P&Z CASE # SP2022-040 P&Z DATE August 9, 2022 CC DATE N/A Approved/Denied

PROJECT NUMBER: SP2022-040
PROJECT NAME: Site Plan for John King Office Park
SITE ADDRESS/LOCATIONS: 1940 N JOHN KING BLVD

CASE CAPTION: Discuss and consider a request by Jeff Carroll of Carroll Architects, Inc. on behalf of Aaron Davis of SBM Real Estates Services for the approval of a Site Plan for an Office Park on a 2.36-acre tract of land identified as Tract 1-2 of the W. H. Baird Survey, Abstract No. 25, City of Rockwall, Rockwall County, Texas, zoned Planned Development District 10 (PD-10) for Commercial (C) District land uses, situated within the SH-205 By-Pass Overlay (SH-205 BY-OV) District, located on the west side of John King Boulevard south of the intersection of John King Boulevard and SH-276, and take any action necessary.

DEPARTMENT	REVIEWER	DATE OF REVIEW	STATUS OF PROJECT
PLANNING	Henry Lee	07/22/2022	Needs Review

**MASONRY
 DUMPSTER
 ENCLOSURE**

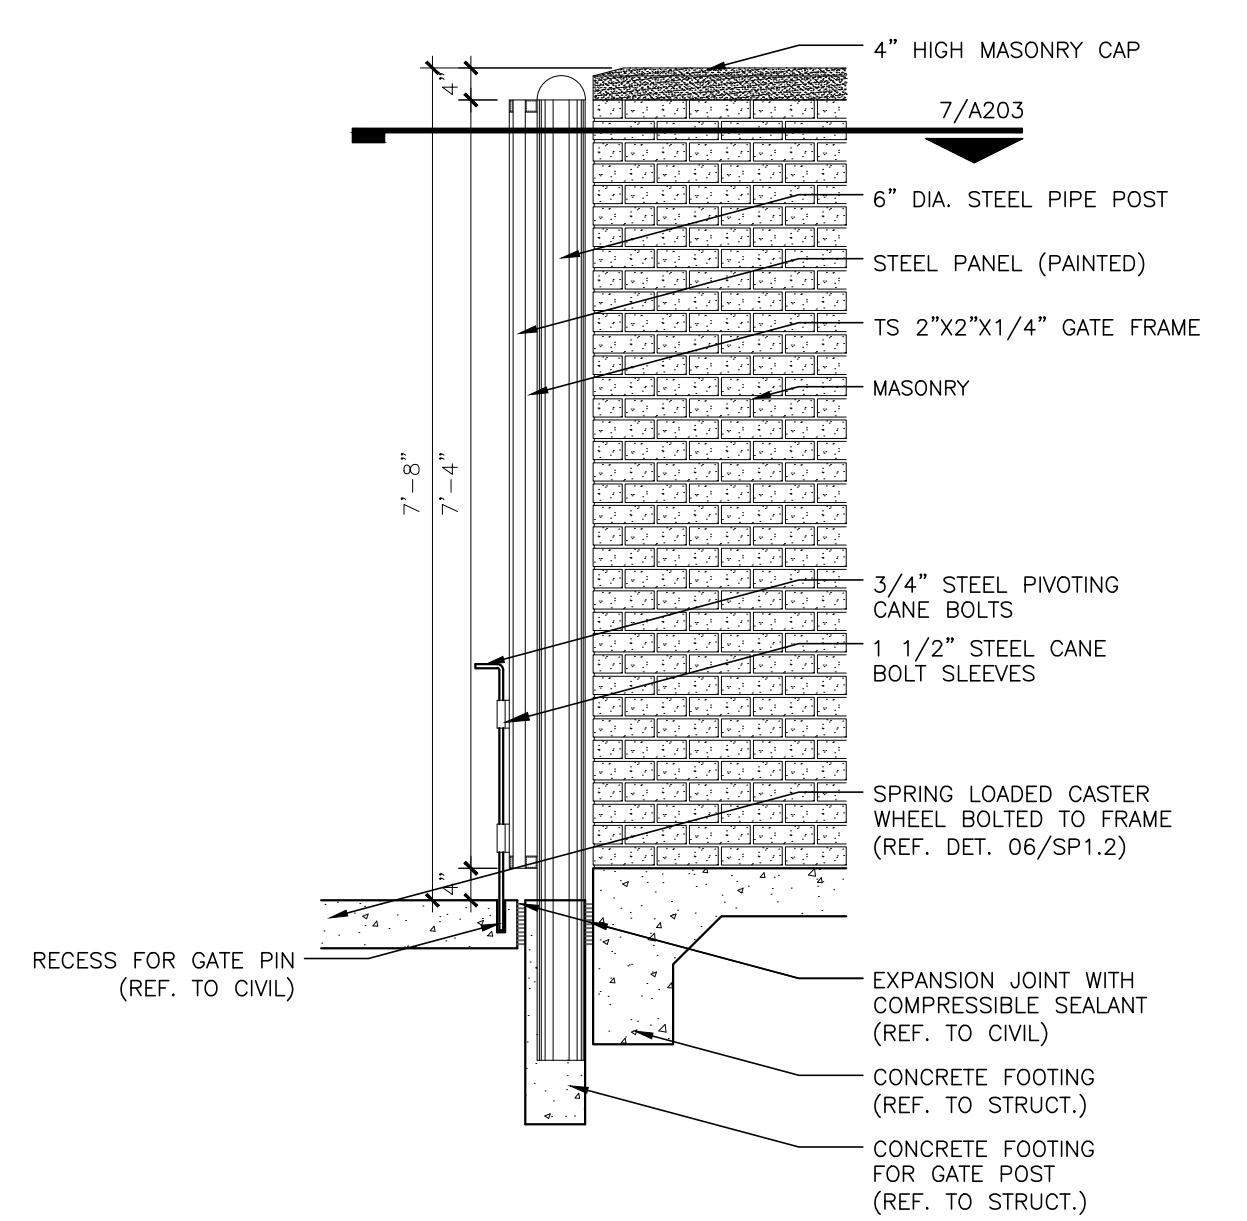
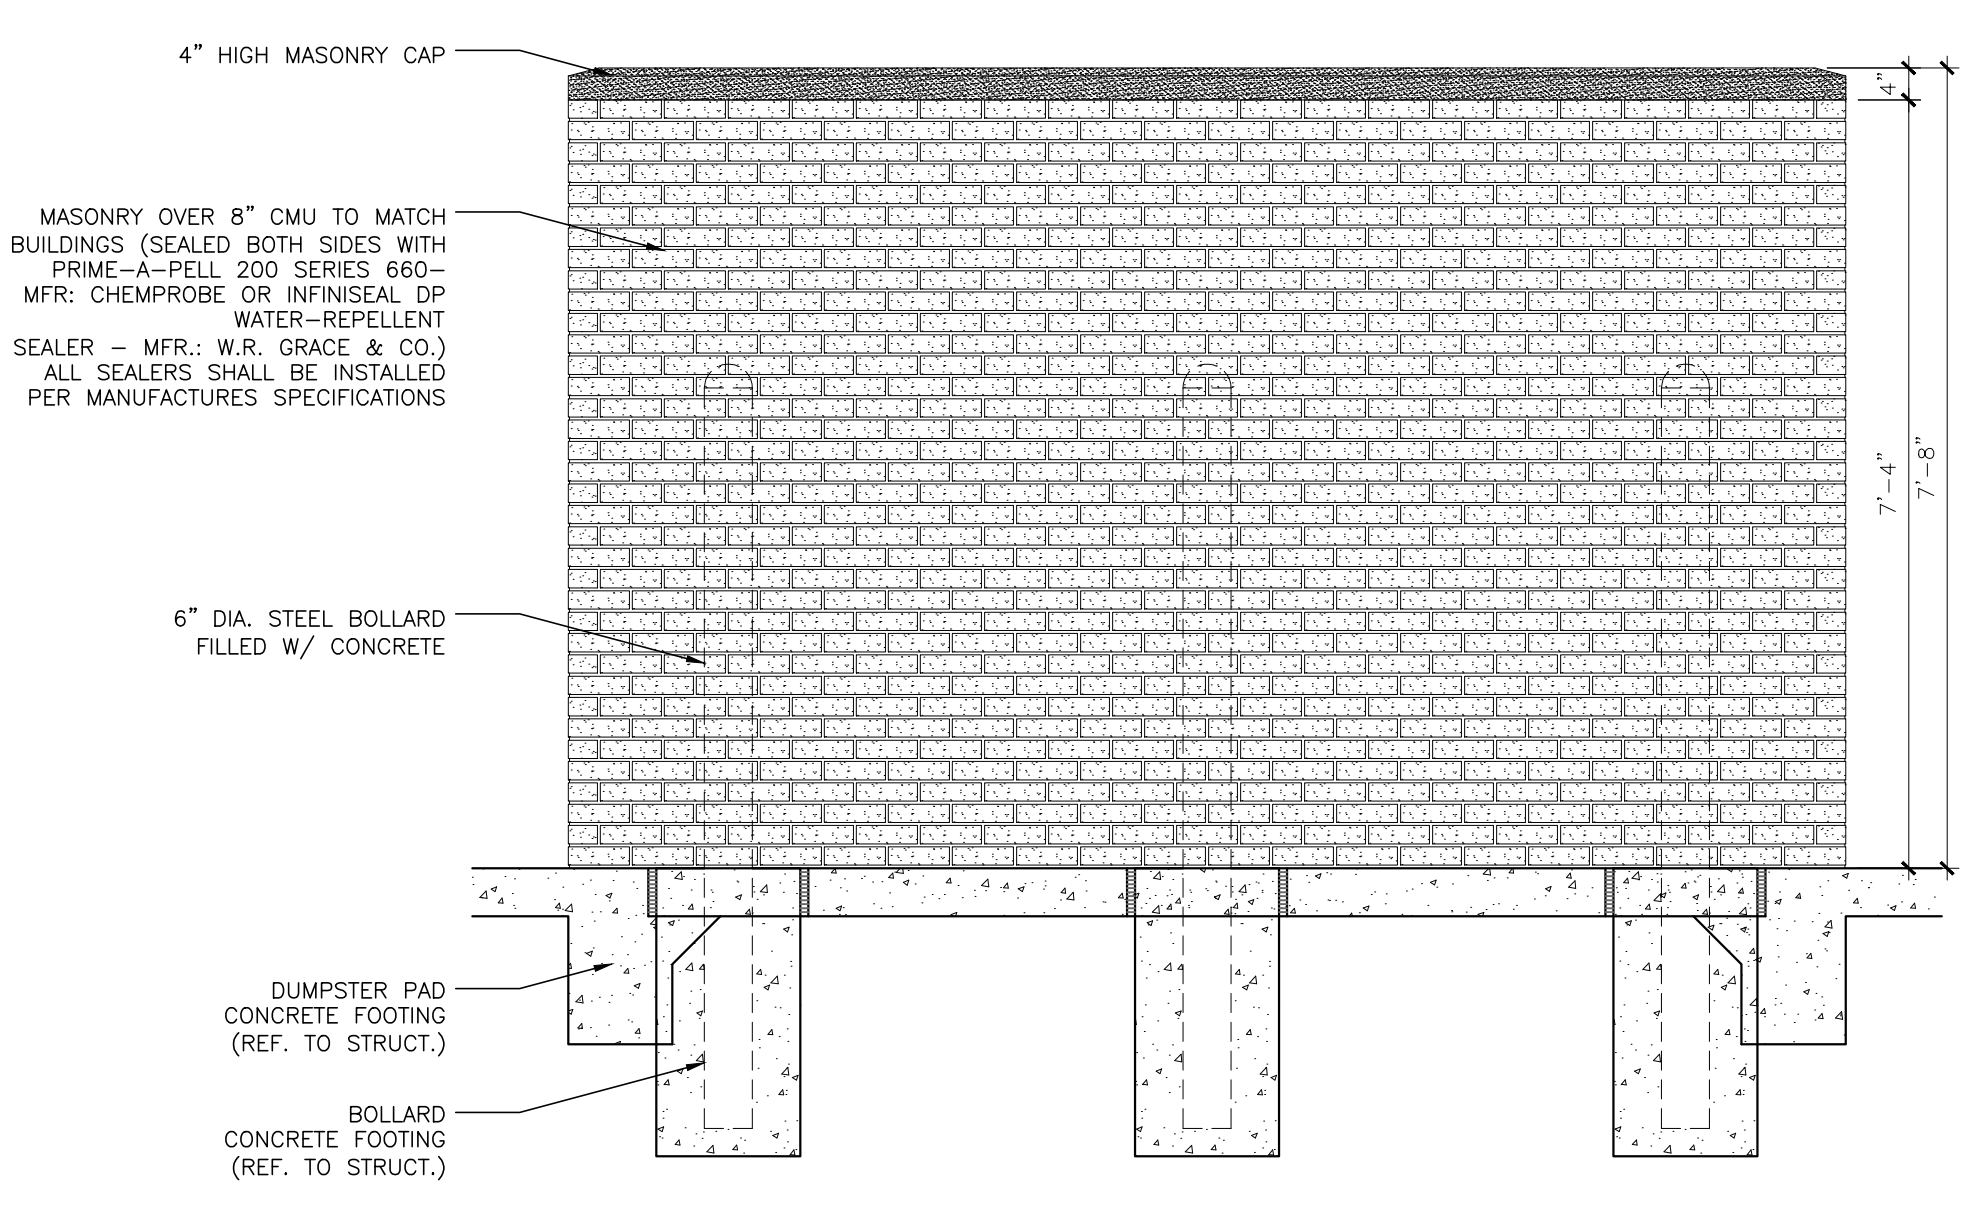
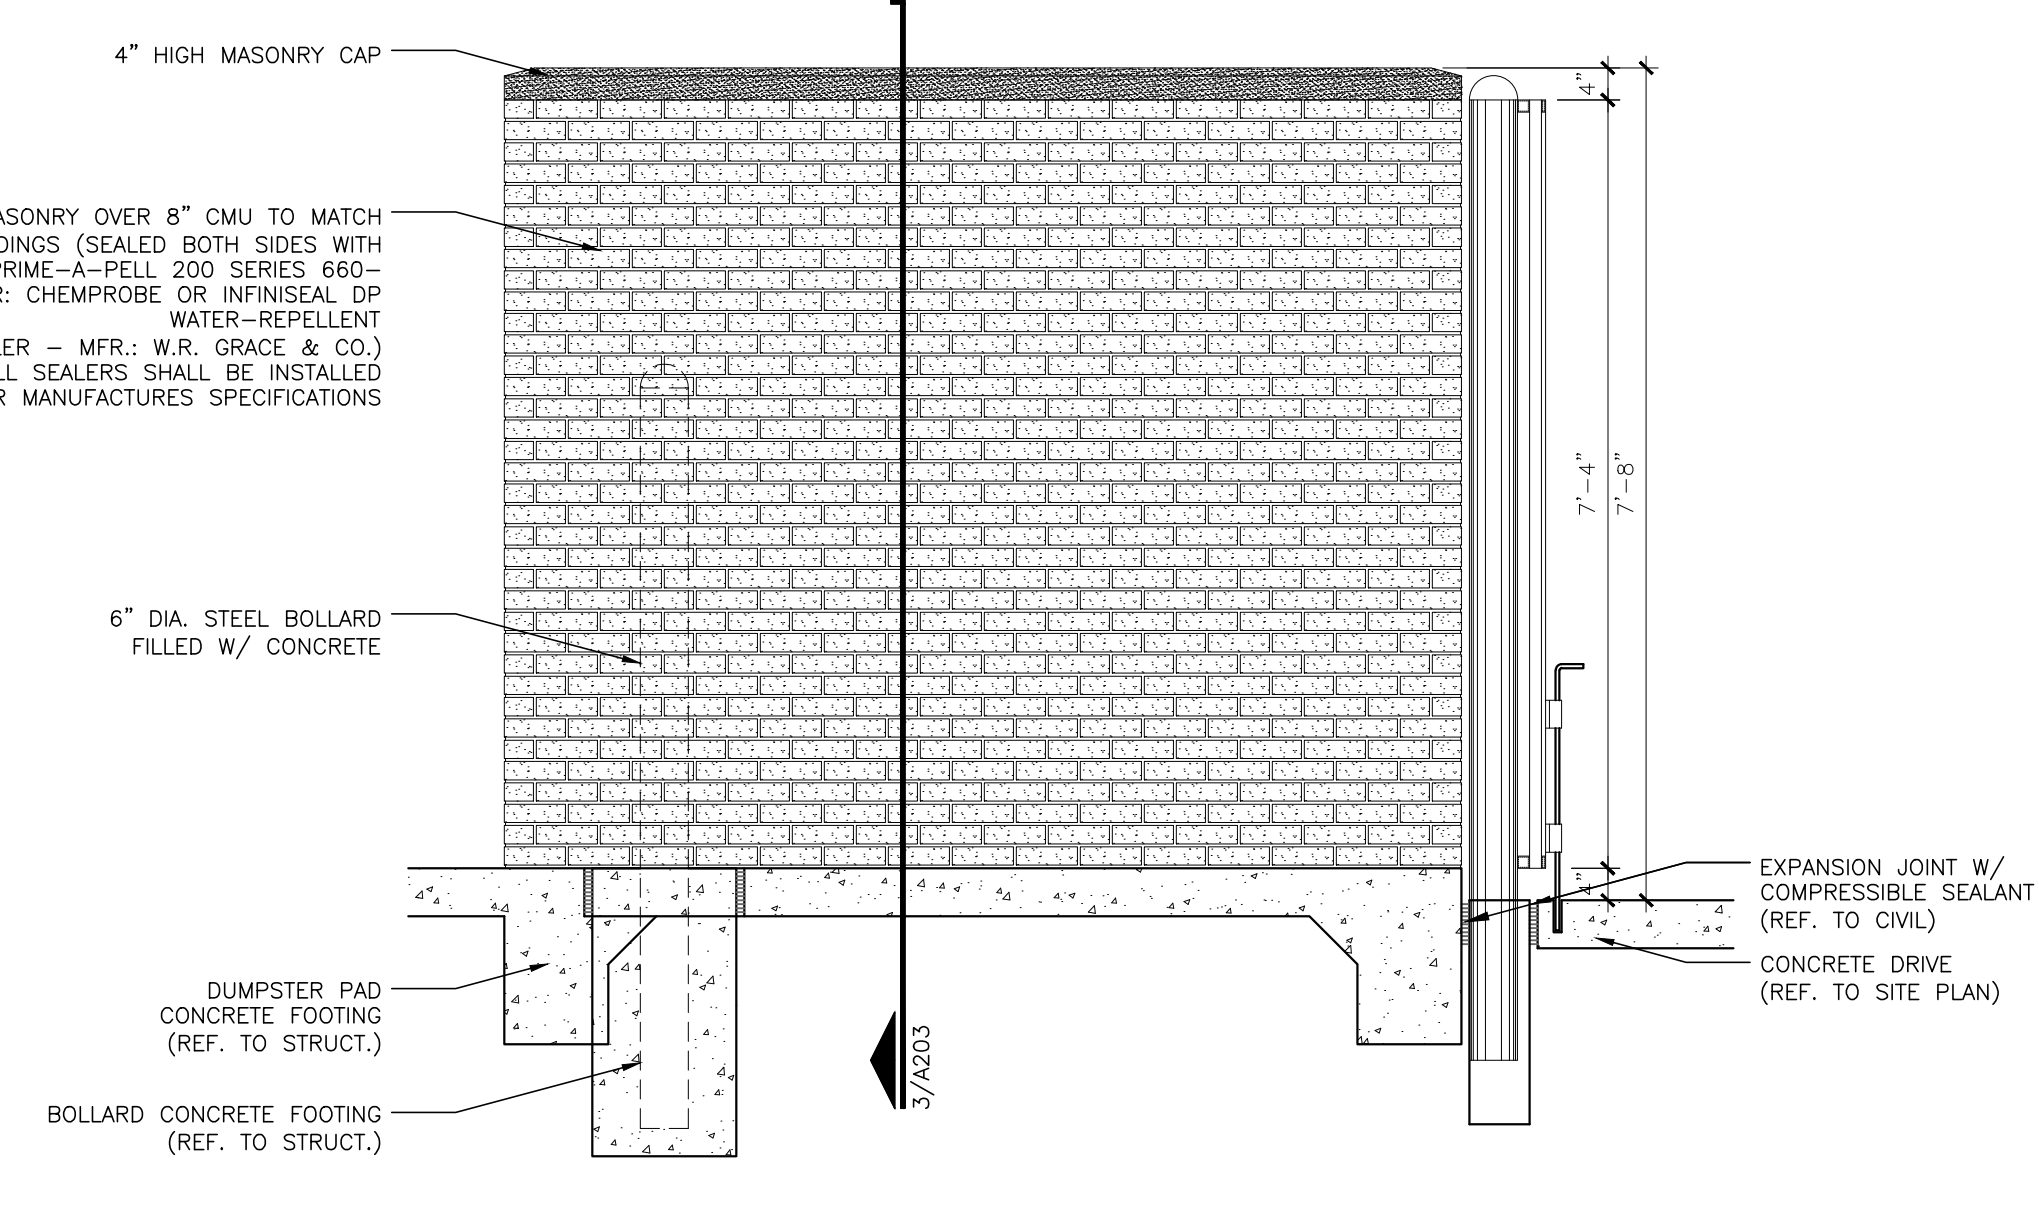
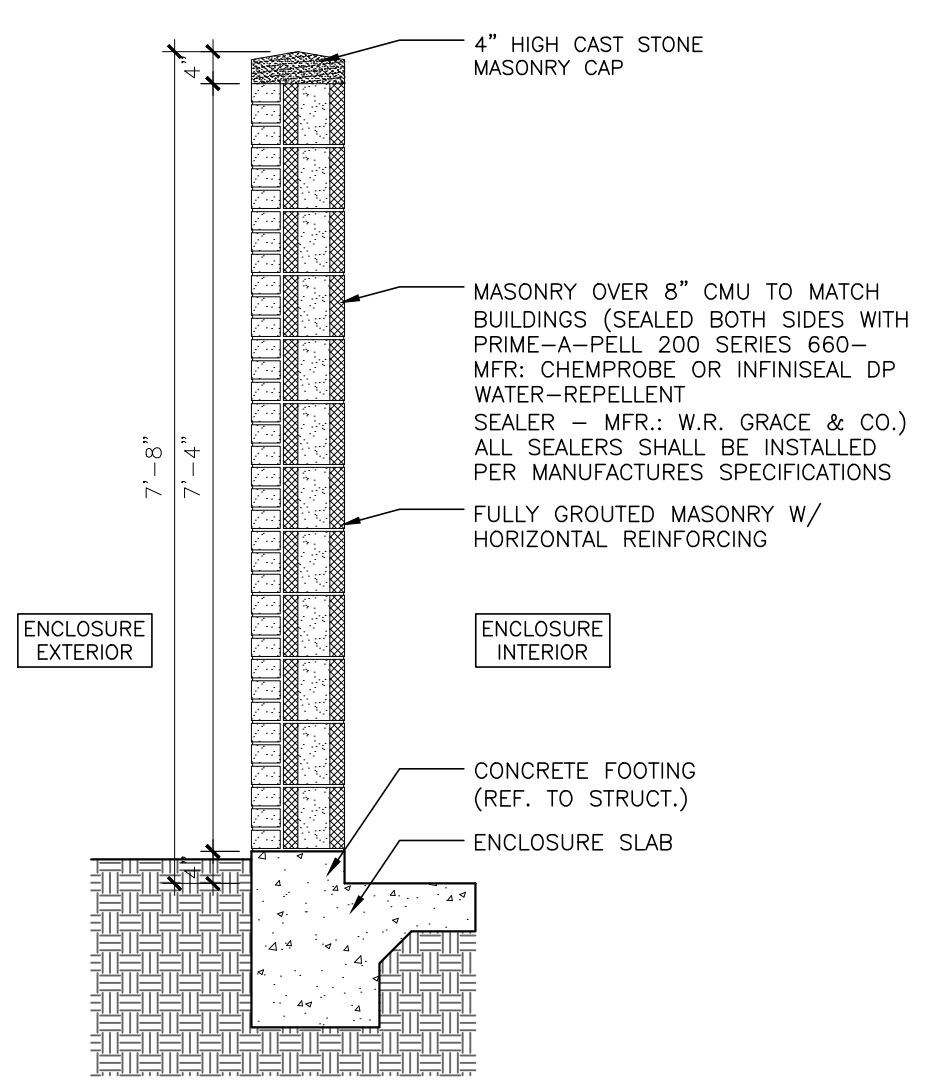
9. Dumpster Screening. The masonry screening wall must be 12-feet by 10-feet, and 8-feet in height because the property is located in an overlay district. The gate must be self-latching and not manual. The dumpster enclosure must be faced in the same material as the primary building. The enclosure must have 5-gallon shrubs planted around it. Please provide a detail. (Subsection 01.05. B, of Article 05)
